**GARD proposal for matters to be addressed by
Ofwat/RAPID in its final decision
on the SESRO Gate 3 report**

28th January 2026

**GARD
Rivendell
142 The Causeway
Steventon
Oxfordshire OX13 6SJ
groupagainstreservoirdevelopment.org
gard.chair@gmail.com**

Figure 2.1 - Comparison of capital carbon ‘hotspots’ between Gate 2 and Gate 3

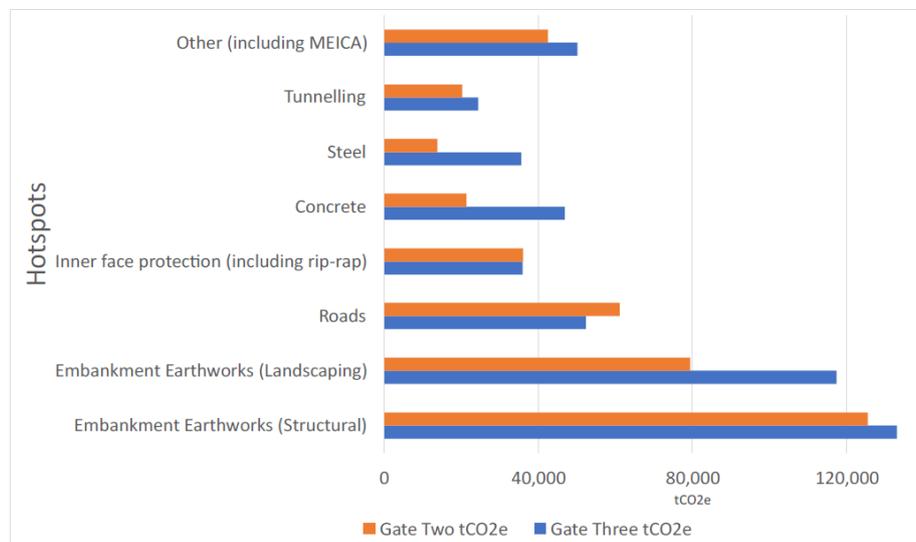
Figure 2.1 highlights the very large percentage increases in the “Steel”, “Concrete” and “Landscaping” carbon emissions between Gate 2 and Gate 3. The “Landscaping” (which in Thames Water’s very broad categorisation will include everything not structurally related to the embankments) is set, as we indicate above, to be substantially increased by the topsoil removal, and the ‘groundwater drain’ (at least 165,000m³ of groundworks, according to Thames Water’s consultant engineers). The latter will also increase the concrete budget and the amount of gravel brought to site.

Figure 2.2 - SESRO operational carbon emissions from the Gate 2 and Gate 3 reports

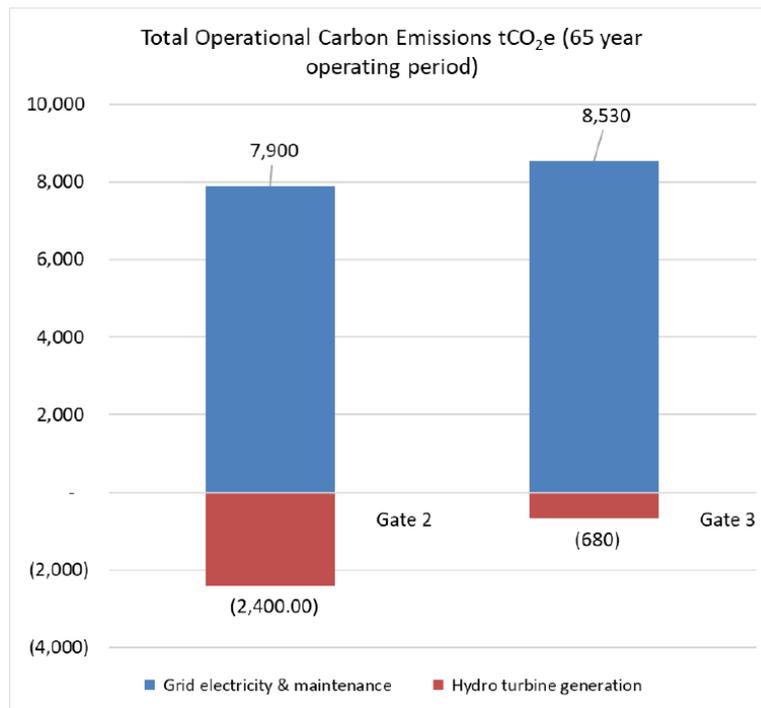
Figure 2.2 (taken from the A2 Carbon Report, figure 8.1) shows a total operational budget of around 8000tCO₂eq (once the returned carbon budget from the outlet hydro-turbines is allowed). The maintenance accounts for 5,190tCO₂eq over the 65 years⁸⁹. A ‘rule-of-thumb’ would nearly quadruple this for a ‘whole life’ of 250 years, consistent with the cost estimate demanded by RAPID. The rough effect of the exclusion of the WTW can be seen by comparison with the figures for Minworth WTW upgrade (GUC transfer) of around

500tCO₂eq per annum.⁹⁰ This equates to around 33,000tCO₂eq over a 65-year period, around four times the SESRO estimate.⁹¹

Figure 2.3 - Carbon emissions from fuel use associated with construction of SESRO, associated rail sidings and materials handling, and the T2ST WTW (from DCO PEI Chapter 17).

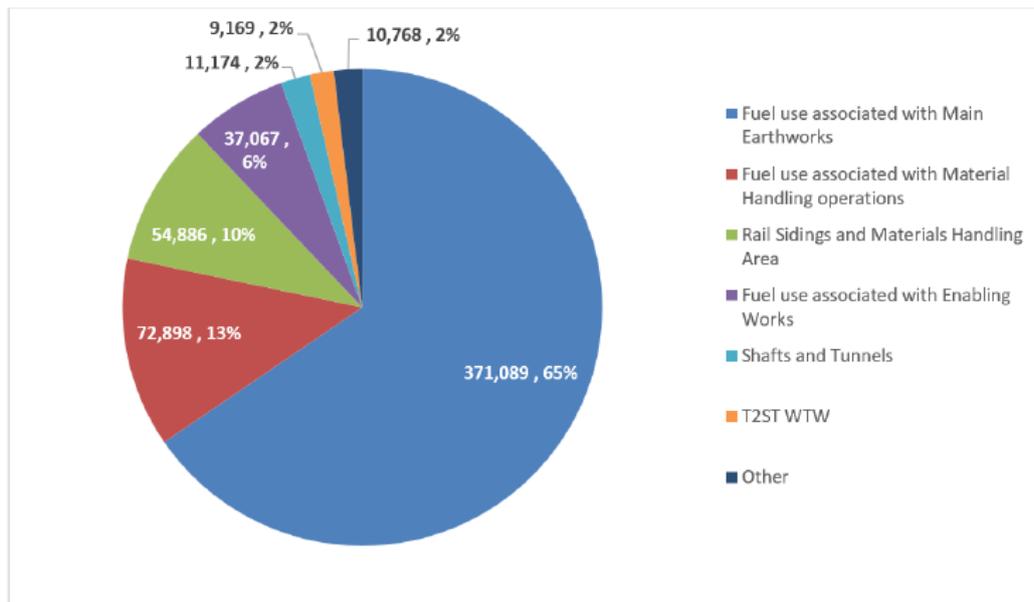
Before leaving the capital carbon estimates, we observe that the increase over the Gate 3 figure must be related strongly to a huge underestimation of the emissions from *Fuel Use associated with the construction*. Figure 2.3 below (taken from the PEI Chapter 17)¹¹⁶ shows a breakdown of this. It is difficult to see anything resembling the numbers in Figure 2.3 being contained in the Gate 3 breakdown in Figure 2.1. The rail sidings seem to have been completely forgotten in Gate 3, and the fuel emissions from the main earthworks is about 150% of the combine embankment and landscaping numbers in Figure 2.1.

Figure 3.2 - WRMP24 modelling over-estimation of winter flow recovery in long droughts

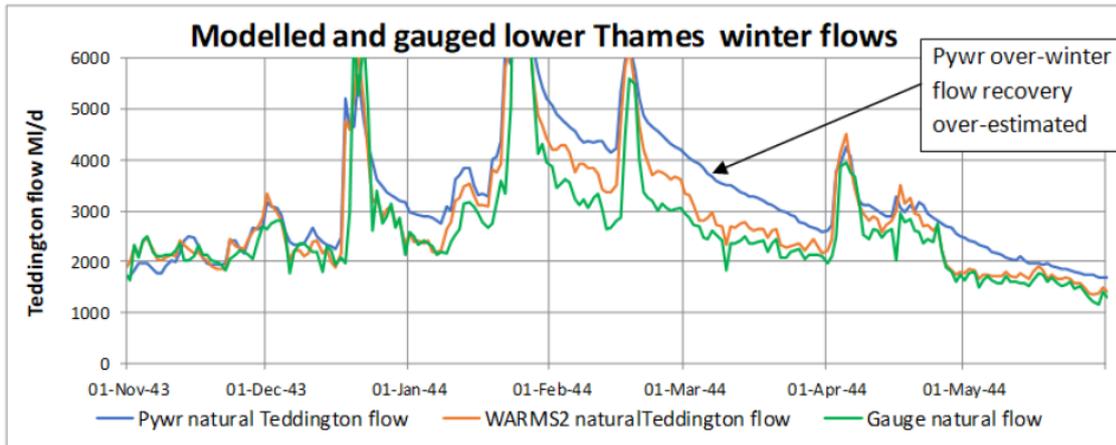
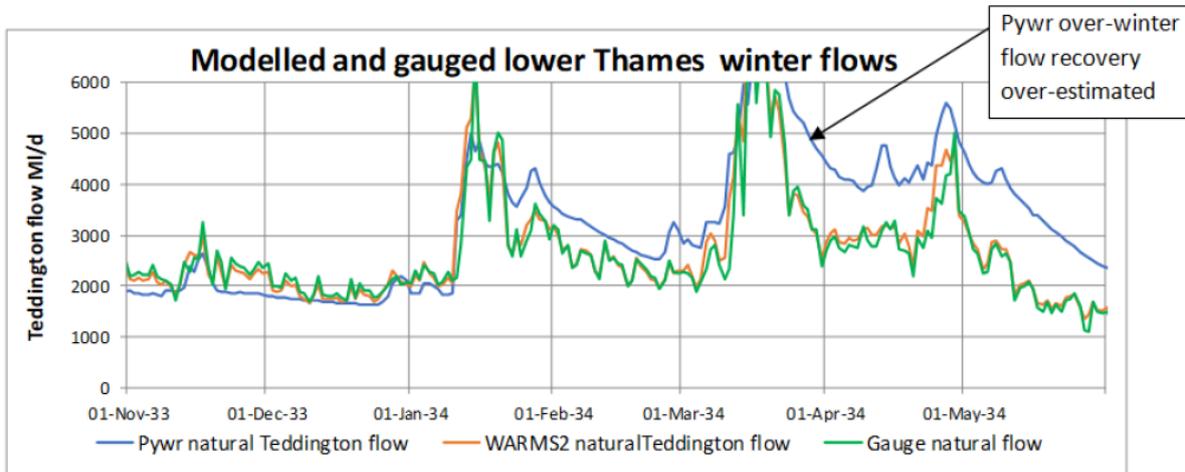
Comparing the latest Teddington modelled flows in the upper plot of Figure 3.2 with GARD’s plot beneath of the previous version of WRMP24 modelled flows shows some slight changes in the latest over-winter flows in 1933–34, but they still greatly exceed the observed flows.

Figure 3.4 - DO vs return period for SESRO 150Mm³ using WRMP19 stochastic data

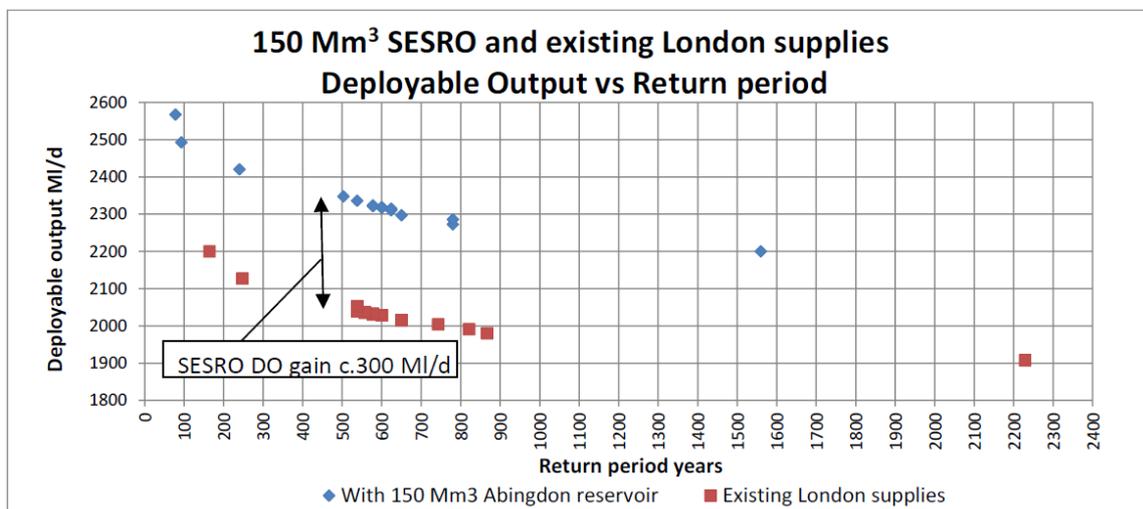
On the face of it, the above plot appears to show that SESRO still provides a 1:500 year DO gain of about 300MI/d when assessed using stochastic data trained on the historic period 1920–97, which includes the 18-month droughts of 1933–34 and 1943–44. However, GARD’s detailed inspection of the modelled failure data provided under EIR-25-26-420 shows anomalies which undermine the credibility of the data and Thames Water’s conclusion that the data show that SESRO is resilient to droughts of longer duration than 18 months.

Figure 3.5 - Calendar-year failure frequencies using WRMP19 and WRMP24 stochastic data

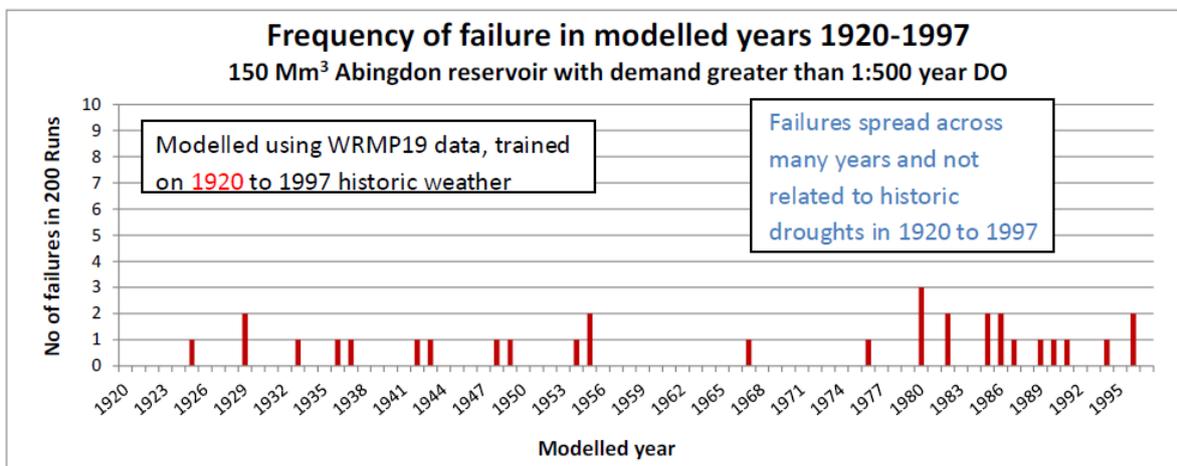
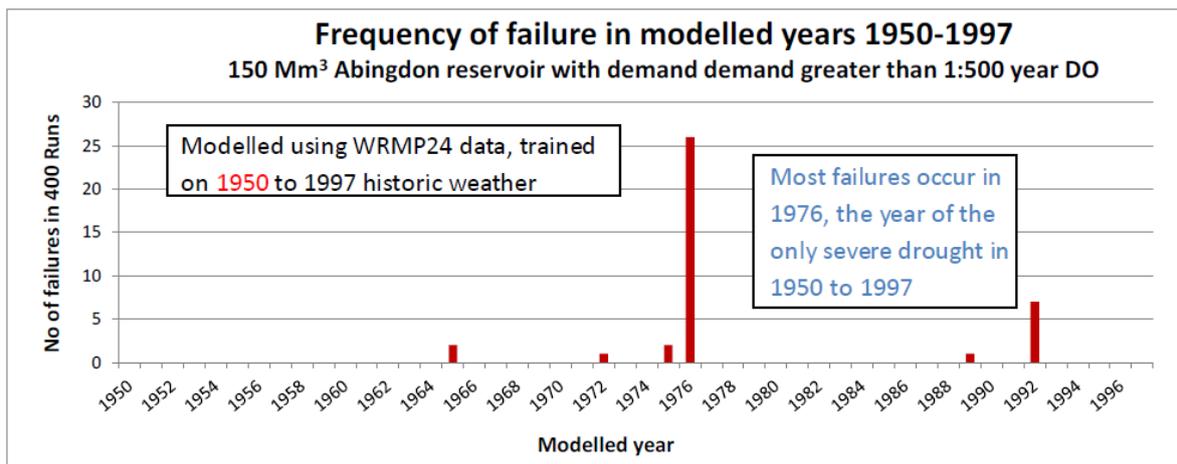
The striking differences in the pattern of calendar years of failure between the WRMP19 and WRMP24 modelling suggests that there has been a fundamental change in the way that the stochastic data have been generated. This needs to be explained and justified by Thames Water.

Figure 3.6 - Example of EIR-25-46-420 data showing SESRO failure but not replicated by GARD modelling using WRMP19 stochastics

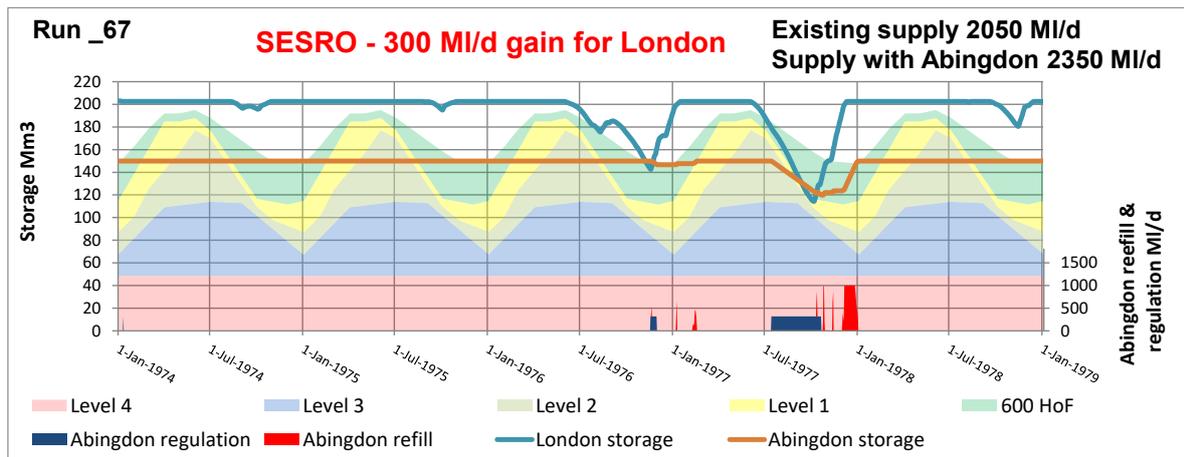
The excerpt in the upper part of Figure 3.6 shows a value of 298 for the year 1975, which the text of EIR -25-46-420 describes as:

The lower part of Figure 3.6 shows GARD’s modelling of the SESRO and London supply system meeting an additional SESRO-supported demand of 300MI/d with the stochastically generated river flows for Run 67 as supplied to GARD prior to WRMP19. The modelling shows little London reservoir drawdown in 1975 (or the surrounding years) and little use of SESRO storage. It appears that the stochastic data used to generate the data files provided

Figure 3.7 - Example of EIR-25-46-420 data not showing SESRO failure, when major failure is shown by GARD modelling using WRMP19 stochastic

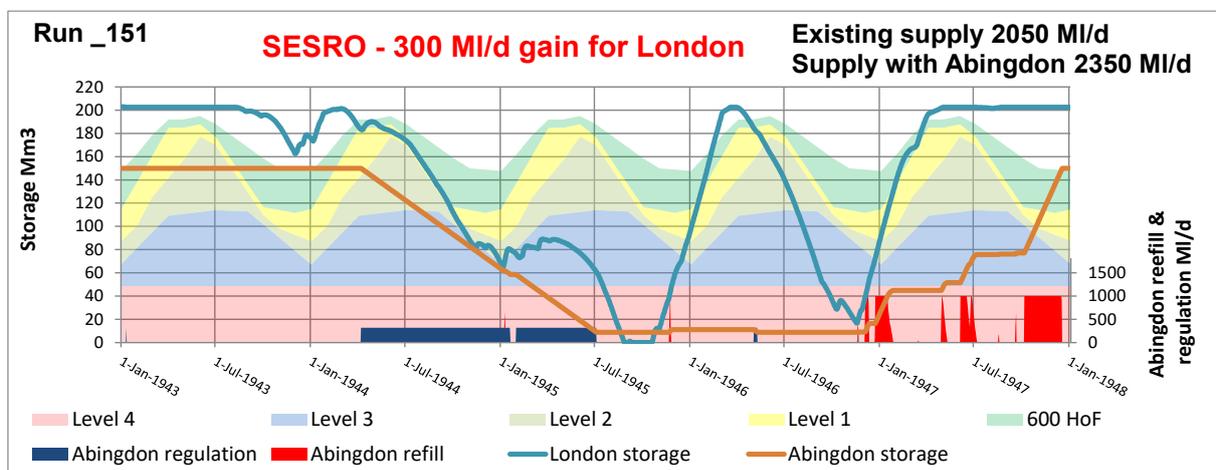
The GARD model output in the lower part of Figure 3.7 shows that, using Run 151 stochastic data, SESRO would be empty by July 1945 and there would be about eight months of emergency restrictions in London, with the London reservoirs **empty** for several months. In the following winter, there would be a full recovery of storage in the London reservoirs, but no water available to refill SESRO. Consequently, with another severe drought following in 1946 and no water available in SESRO, there would be another several months of emergency restriction for London in 1946. The possibility of this nightmare scenario of a three-year drought was dismissed by Thames Water as being too improbable to contemplate. In GARD’s opinion, Thames Water has provided no analysis or data that reliably proves that a catastrophic three-year drought does not need to be considered in assessing the DO.

Figure 3.8 - Abingdon Reservoir in artificially extended historic 1934 drought

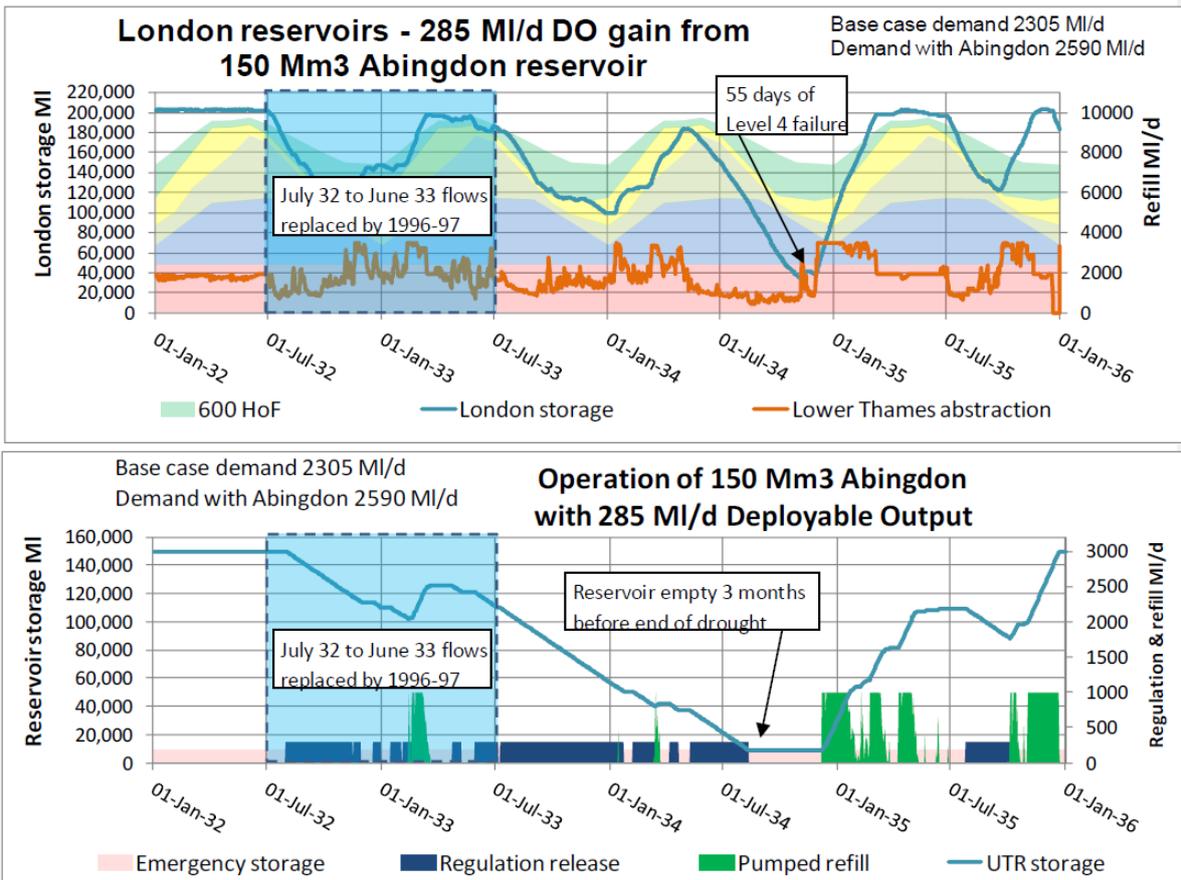
GARD’s Addendum to the WRMP24 consultation response provided an example of a long artificial drought, with the historic drought of 1933–34 being preceded by the flows of the moderately dry years 1996–97. This showed there would be catastrophic failure of London’s supplies during such an event and the DO of the 150Mm³ SESRO Reservoir, without climate change, would fall from 285MI/d to 163MI/d¹⁴⁹. GARD’s modelling to support this conclusion is shown in Figure 3.8 below.

In this scenario, replacing the historic flows of mid-1932 to mid-1933 with the historic flows of mid-1996 to mid-1997 would lead to 55 days of Level 4 failures for London’s supplies, with SESRO being empty three months before the end of the drought. This would be a catastrophic failure of London’s supplies, with Level 4 restrictions starting in August 1934 at the peak of the tourism season. In this seemingly plausible scenario, the DO that can be sustained by SESRO is only 163MI/d, not 285MI/d.

Figure 3.9 - Favoured option (option C) for emergency discharge tunnel as at August 2024

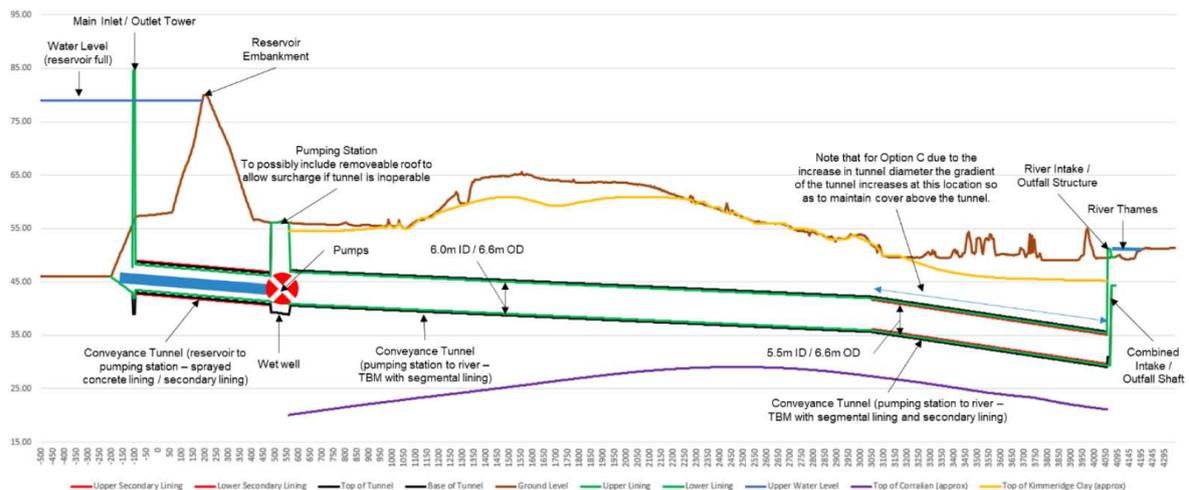
- Finally, it will not have escaped notice, in looking at Figure 3.9 and Figure 3.10, how close this emergency drain tunnel is to the Abingdon treatment works. We have no details (either written or verbal) on how the discharge would be designed, other than a rather flimsy assertion that it would be directed (somehow) downstream. It is a common observation on structures like this that a counter current would be

Figure 3.11 - Plan and elevation of discharge tunnel at the River Thames end

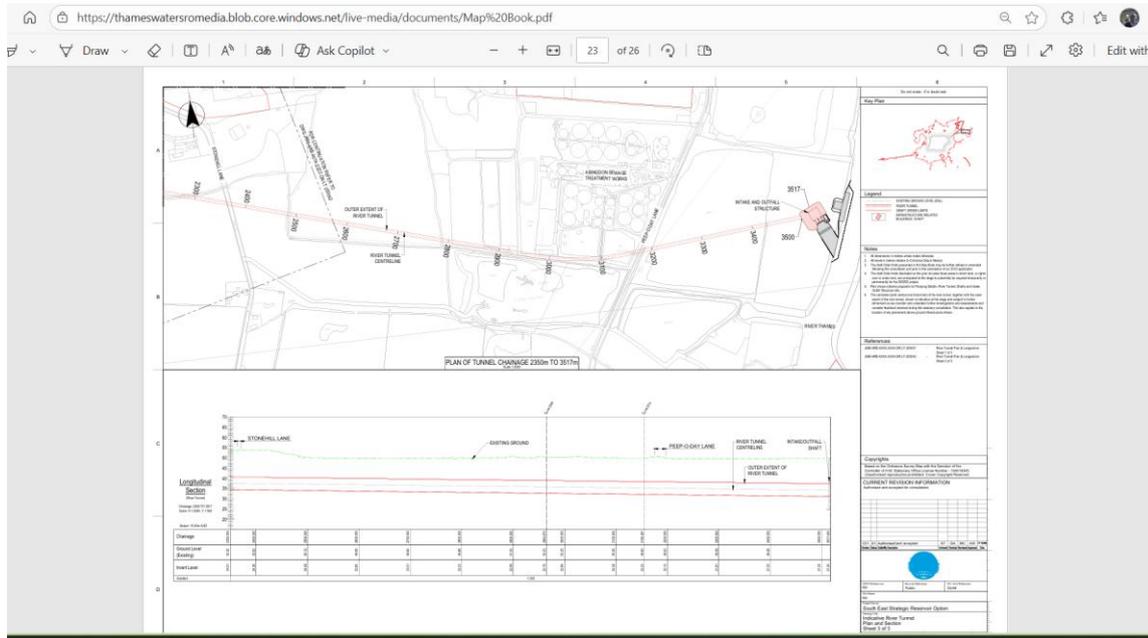
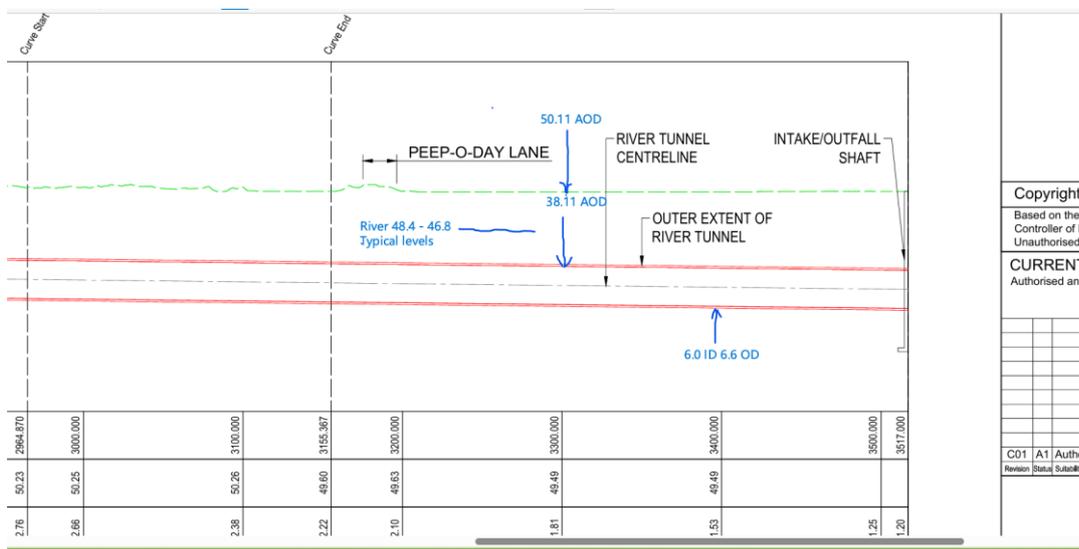
- The real significance of the data in Figure 3.11 can be seen in that the nearest river datum is 44.9mAOD and the typical range is 1.9–3.5m above surface datum (ASD¹⁷⁶), giving an average river level of $(44.9 + 2.7) = 47.6\text{mAOD}$. This should also be the water level in the gravel pit. This level is determined by the river level, not directly as there is no such connection, but indirectly through ground water transfer. This is why the gravel pit water is clear and pollutant-free. Thames Water will have to build a coffer dam at the outfall tall enough to ensure that the river is kept out of the construction during a flood flow; for example with a Q5% exceedance¹⁷⁷ of $100\text{m}^3/\text{s}$.¹⁷⁸ The consequences of failure of this coffer dam, under emergency discharge conditions of an extra $76\text{m}^3/\text{s}$, would be serious for the local population.
